PRODUCT CHANGE NOTIFICATION
PCN-000907
Date: May 16, 2023

Qualification of Greatek Taiwan as Alternate Final test source
Facility for SX1211I084TRT , MRF89XAIWLTRT

FROM-TO Summary of Electrical Final Test Facilities

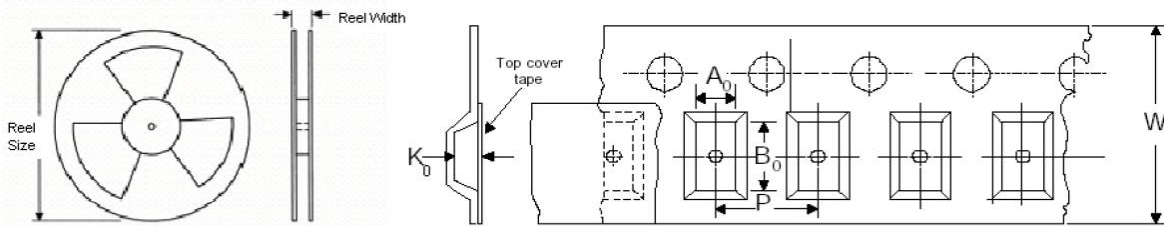
Current Supplier: Carsem (Malaysia)	Alternate Supplier: Greatek (Taiwan)
Test Platform	Teradyne FLEX	Teradyne FLEX
Manufacturing Qualification (Final Test)	In production	Qualified and Concluded as PASSING: - FT yield : 96% (< 2k units Lot size)
Cross Test Validation (Valid electrically Pass and Fail Parts)	10 pcs Golden Passing samples 10 pcs Valid Failing samples (with traceable serial marking)	10 pcs Golden Passed samples – Test results reproduced 10 pcs Valid Failing samples – Test results reproduced
Post-Final Test Packing material (Supplier)	Tape & Réel (C-Pack)	Tape & Réel (Advantek) - No change in specs and dimensions
Tested Customer samples	Available	Available
Status	Production	Qualified

Carrier tape for Greatek 5x5 (New)

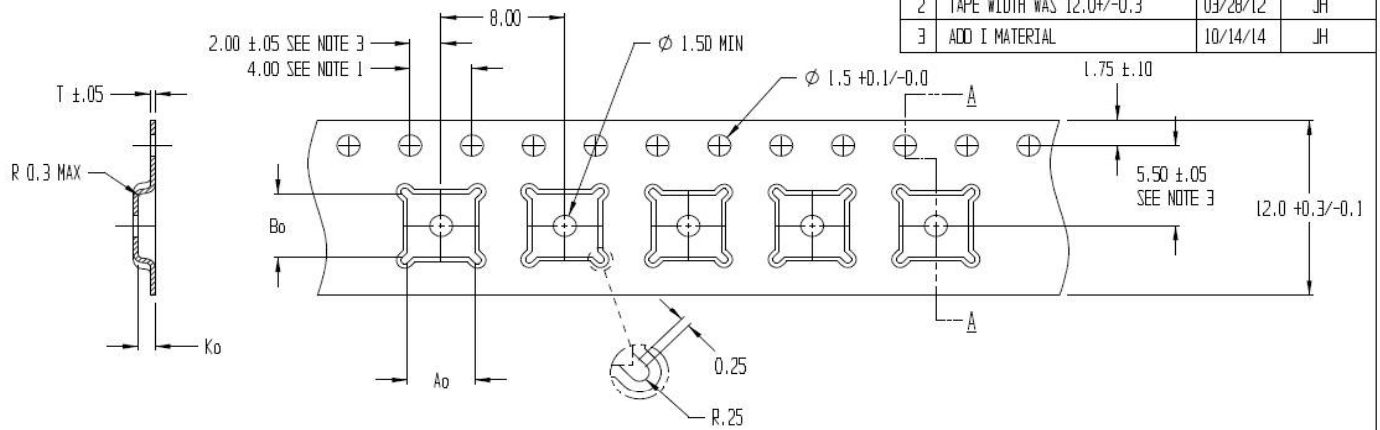
Although carrier tape supplier were different but critical dimension were no difference.
